LIVING WITH HISTORY

Certificate of Appropriateness

Property	3402 W. ST PAUL AV. Weinstock House, an individually-designated local register structure
Description of work	Replace all existing vinyl windows (non-original) with new all-wood windows (both inside and out) to match the molding profiles, sizes and design of the existing wood windows on the house. Replace large, landscape sash on first story of front elevation with a new, all wood, landscape sash to match the original landscape sash window on the east elevation of the first story. Repair existing wood windows using modern wood epoxy restoration techniques whenever possible. Replace missing rafter tail details where necessary using clear western red cedar. Replace missing colonnette on side porch on east elevation with a new, turned wood colonnette to match the existing original one. Replace missing wood brackets on third story of corner tower with clear wood brackets to match the originals. Construct new wood porch stoop according to attached drawings. Replace existing steel basement bulkhead doors on north elevation with new Bilco-type metal doors in same location and to the same size and general design. Repair south dor

3402 W. St. Paul

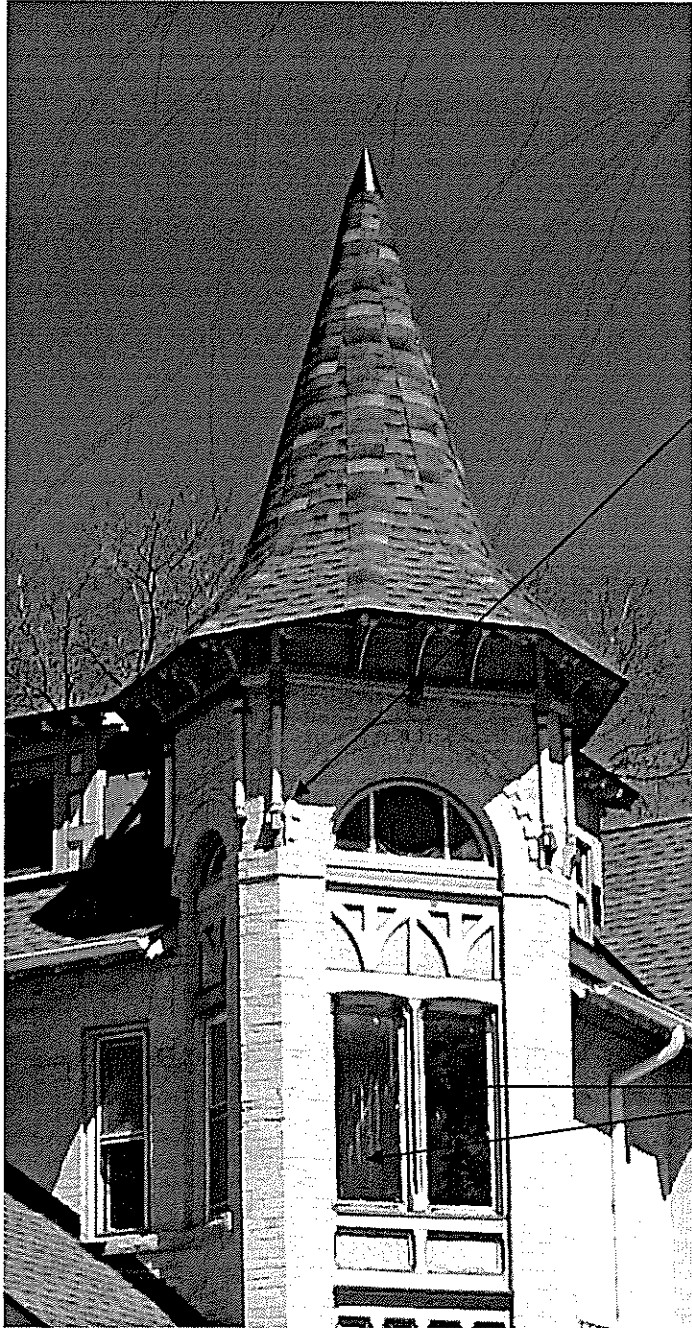
Vinyl windows to be replaced with new all wood windows to match original profiles and sizes

Front landscape sash, a replacement, will be replaced with a new landscape sash unit that will match identically the landscape sash window on the east elevation

Glass block windows in front to be removed and replaced with wood windows or hidden by foundation plantings

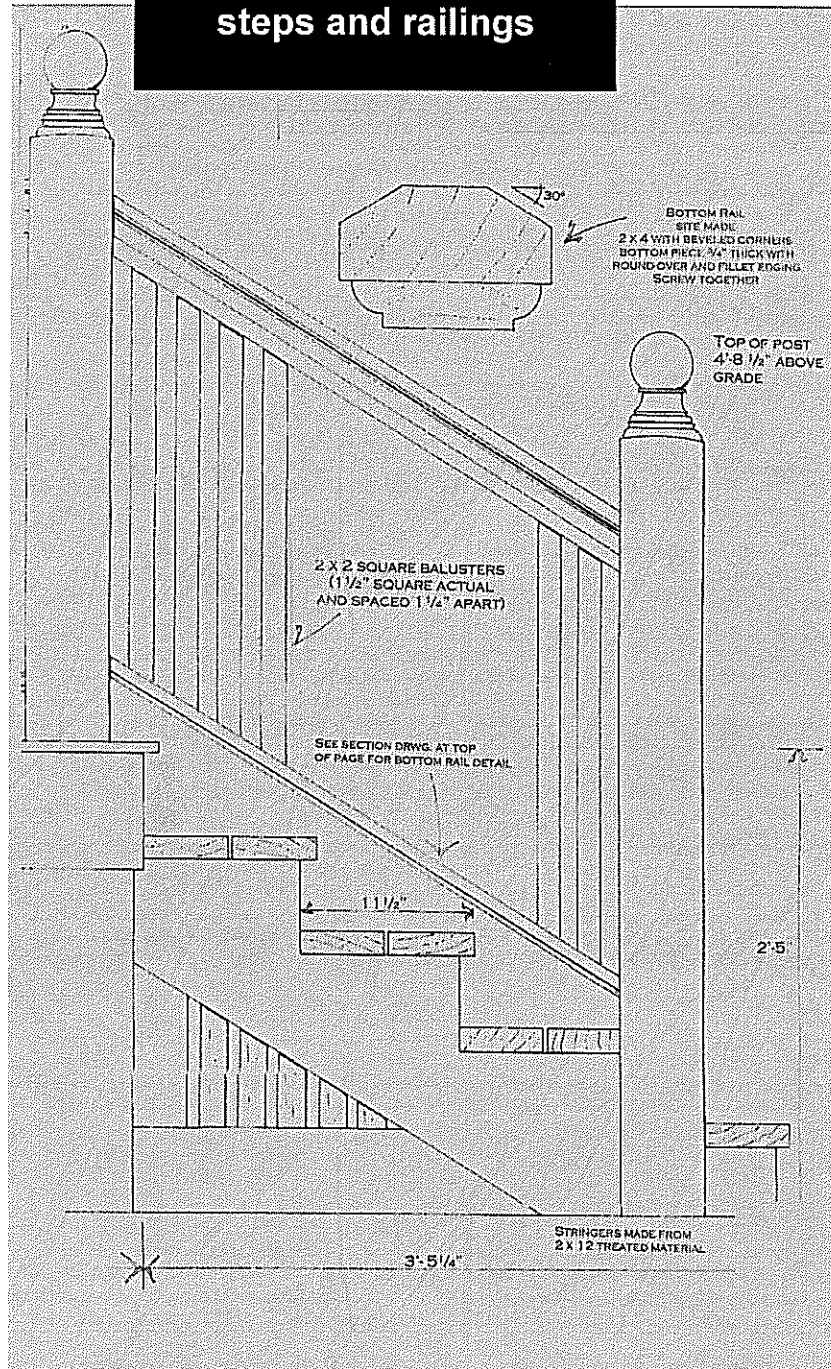
Bermed grass lawn to be retained

**Missing wood brackets
to be replaced with new
identical copies of
original brackets made
of clear wood in a
naturally decay resistant
wood species.**

**These windows to be
repaired or new all wood
sashes made to duplicate
the originals**

Design for rear stoop, steps and railings

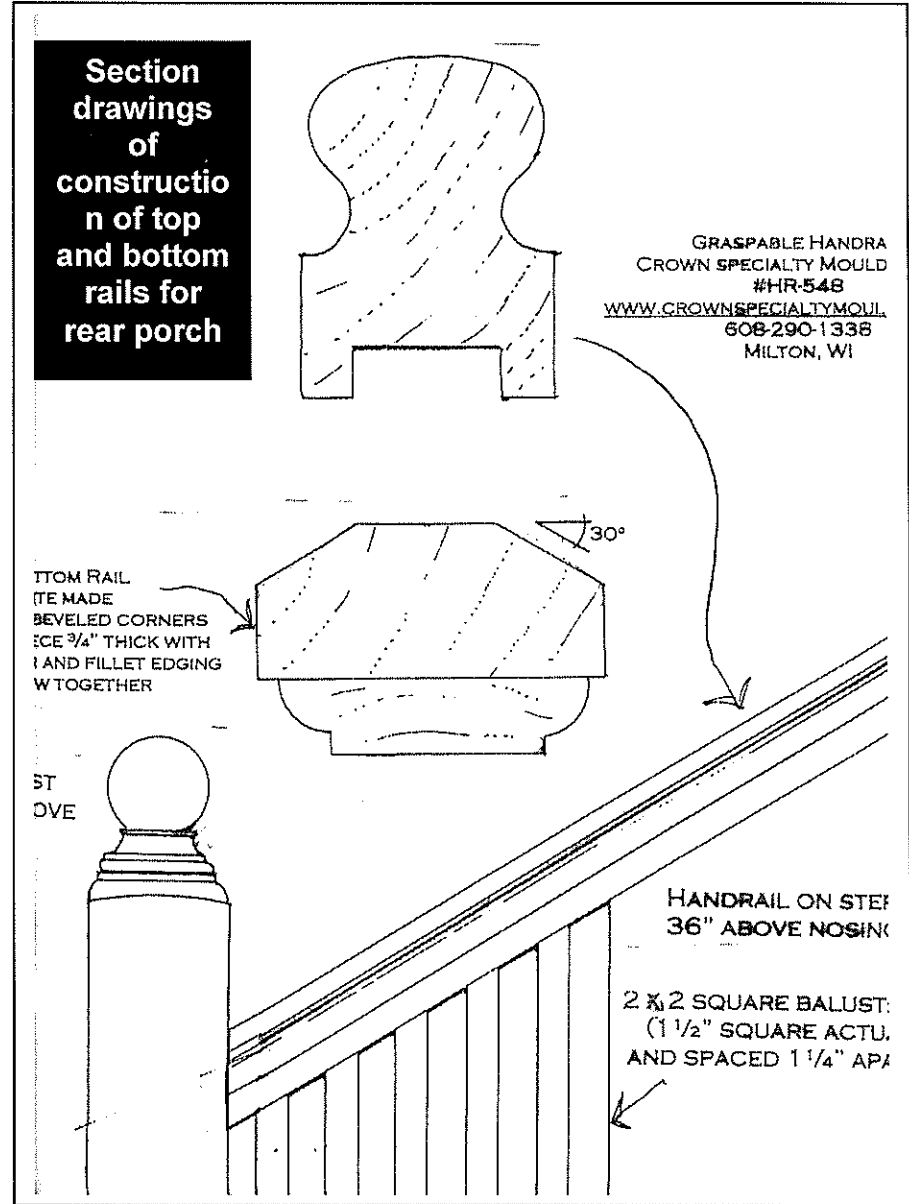
Section drawings of construction of top and bottom rails for rear porch

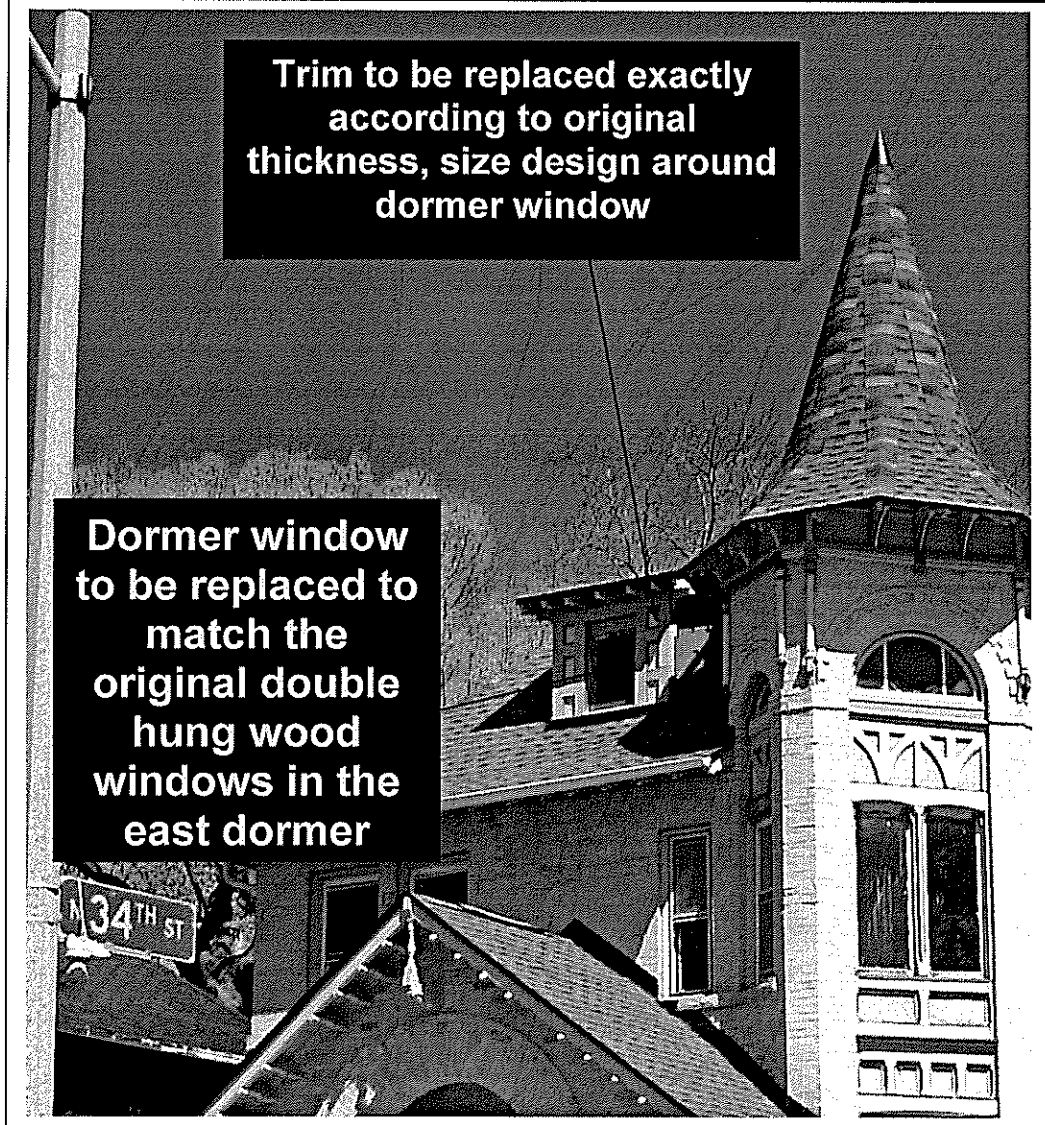
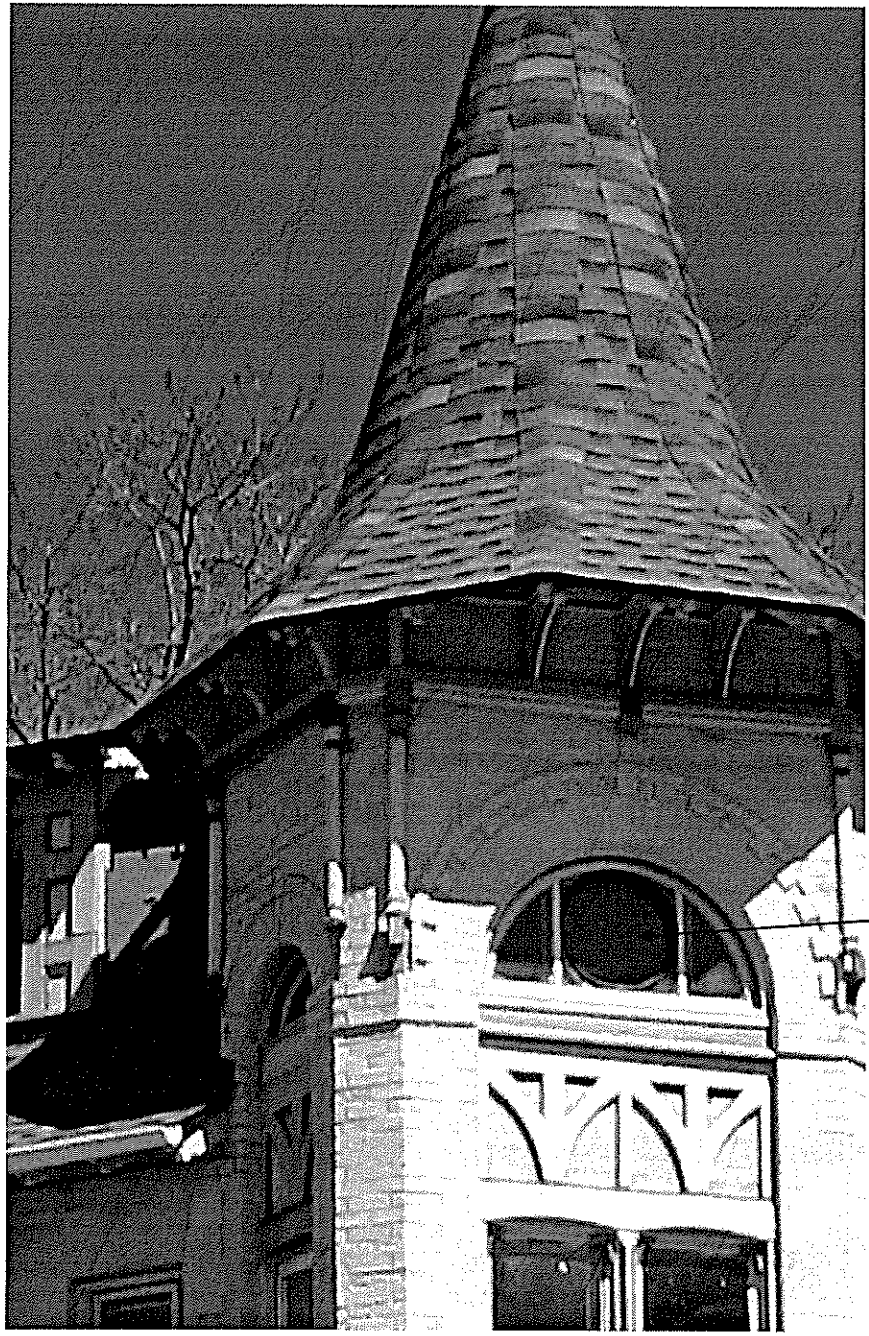
**Trim to be replaced exactly
according to original
thickness, size design around
dormer window**

**Dormer window
to be replaced to
match the
original double
hung wood
windows in the
east dormer**

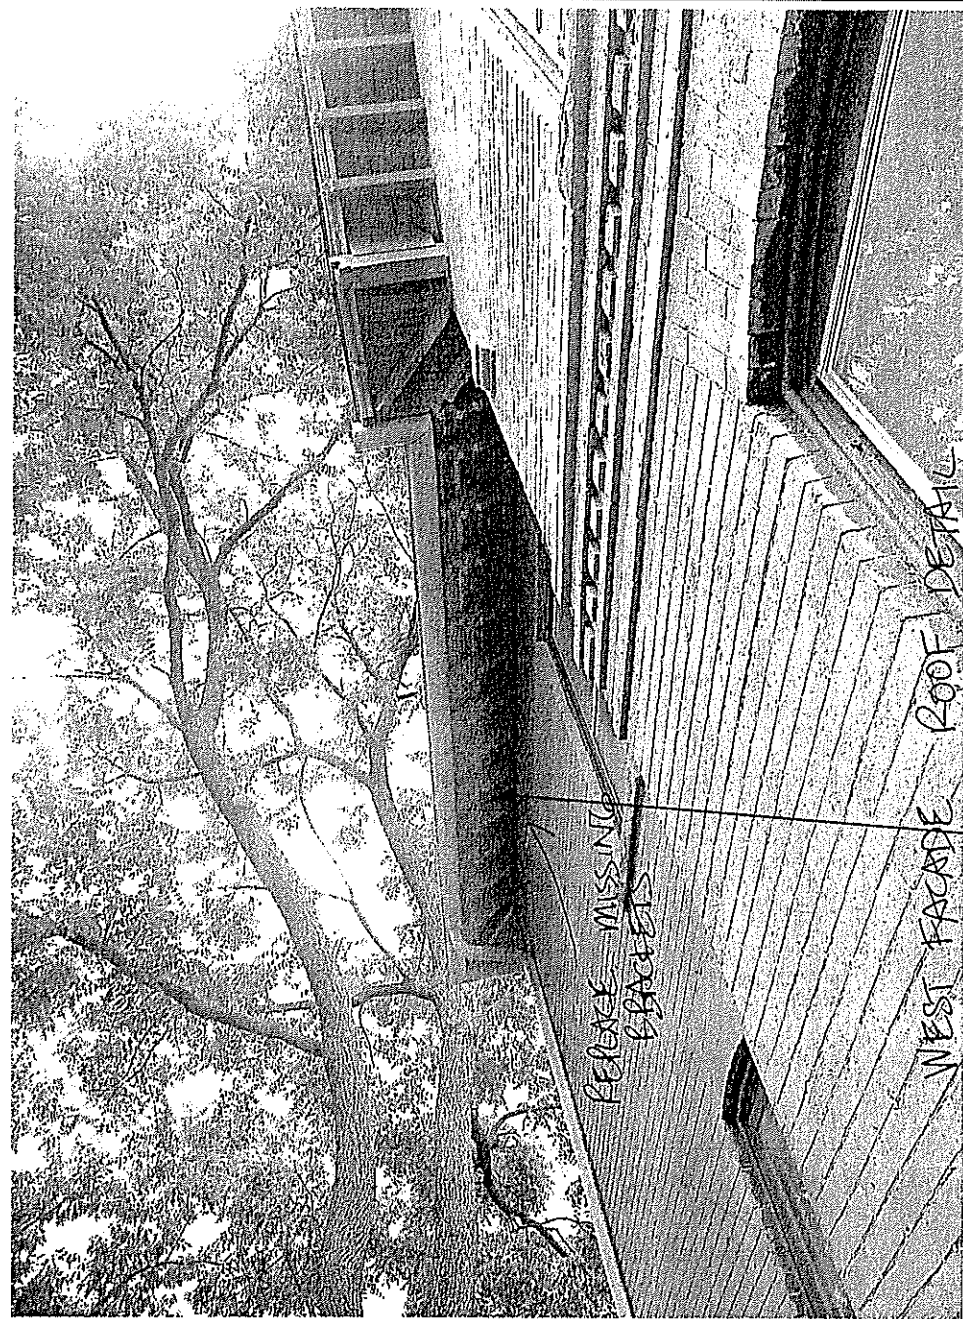
**Art glass oculus
(round window) may
be installed in place
of clear glass**

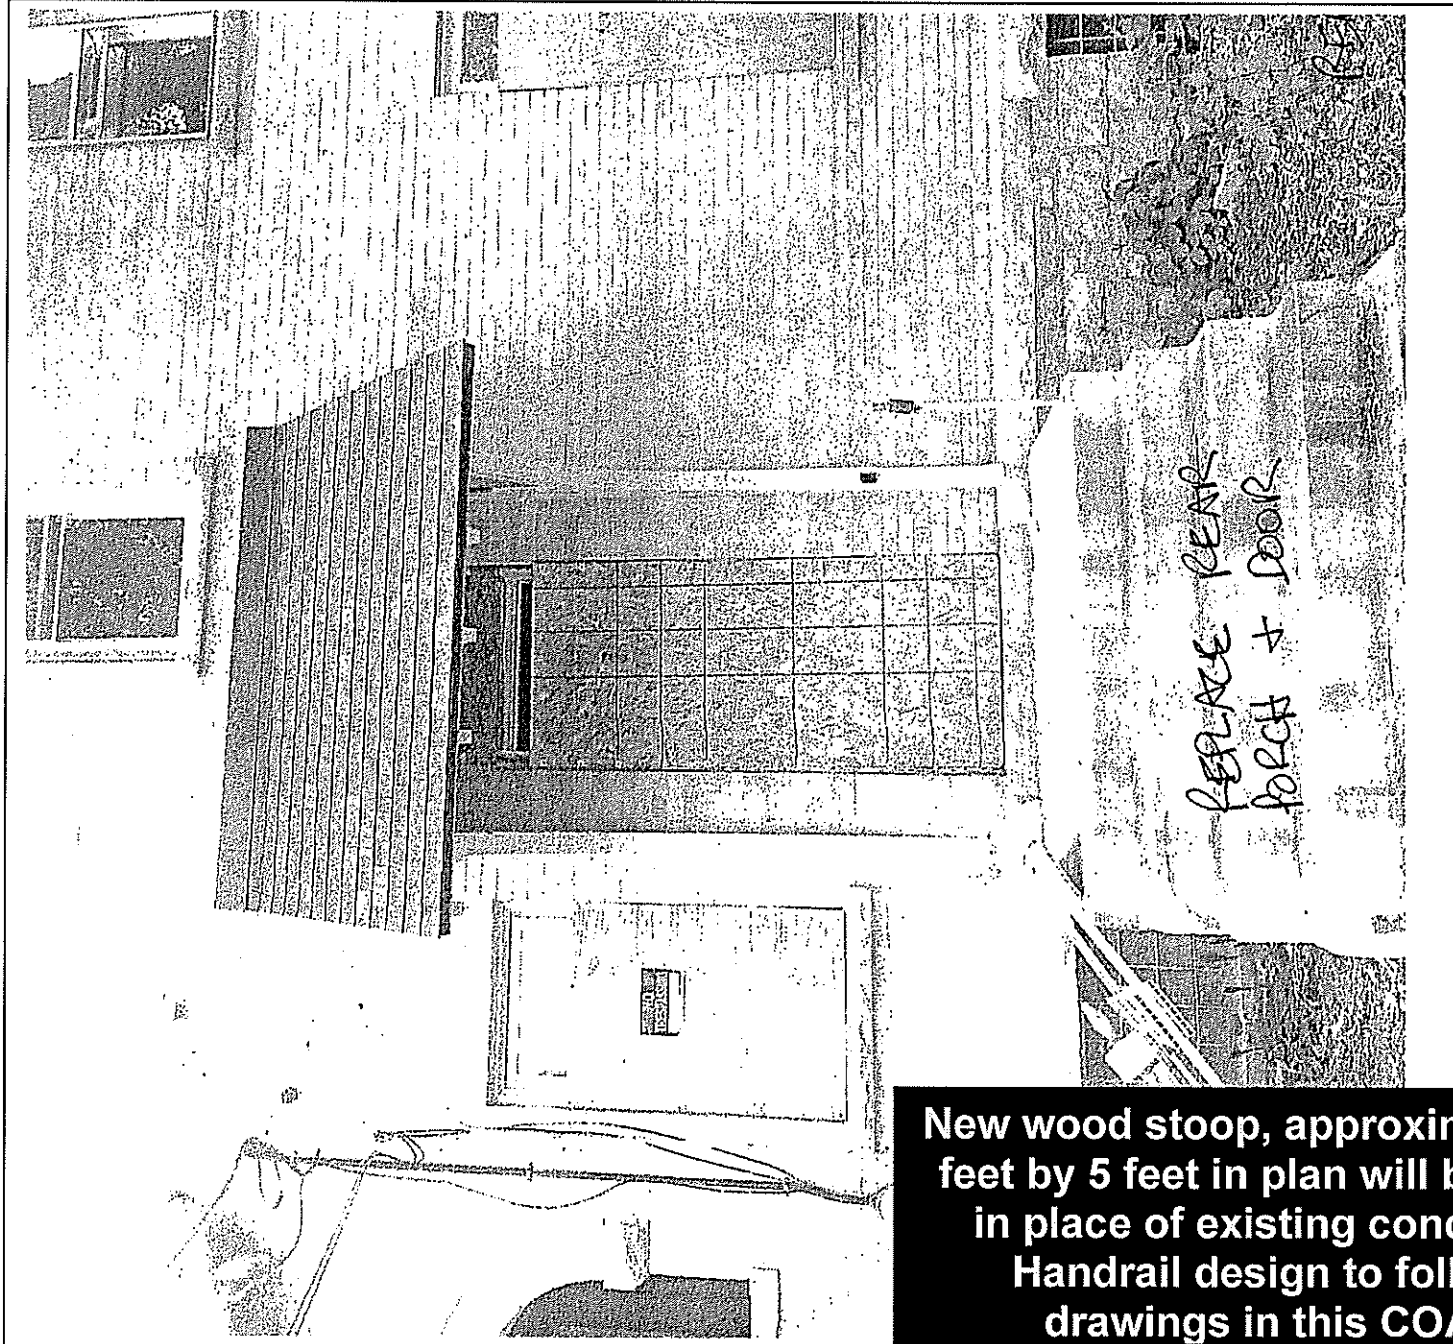
Rafter tails will be replaced where missing or deteriorated. All new wood must be clear and free of knots and should be of a naturally-decay resistant species such as western red cedar or Spanish cedar.

New wood stoop, approximately 5 feet by 5 feet in plan will be built in place of existing concrete. Handrail design to follow drawings in this COA.

Traditional Porch Floors

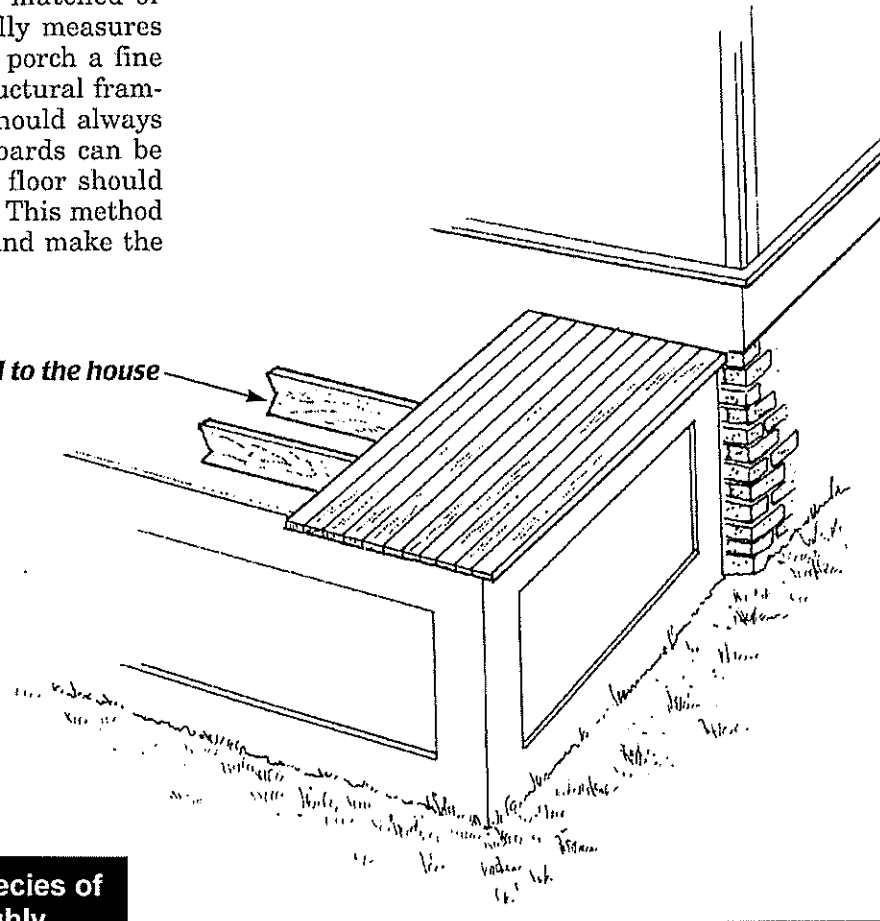
Porch floors should be constructed of center matched or tongue-and-groove wooden flooring, which typically measures 2-1/4" wide by 3/4" thick. This flooring gives the porch a fine finished appearance. The joists, which are the structural framing members to which the flooring is attached, should always be run parallel to the house so that the floor boards can be installed perpendicular to the house. The porch floor should also be very slightly pitched away from the house. This method of construction for a porch floor will shed water and make the porch last longer.

Rear Porch deck. A decay resistant species of center match flooring such as Ipe is highly recommended.
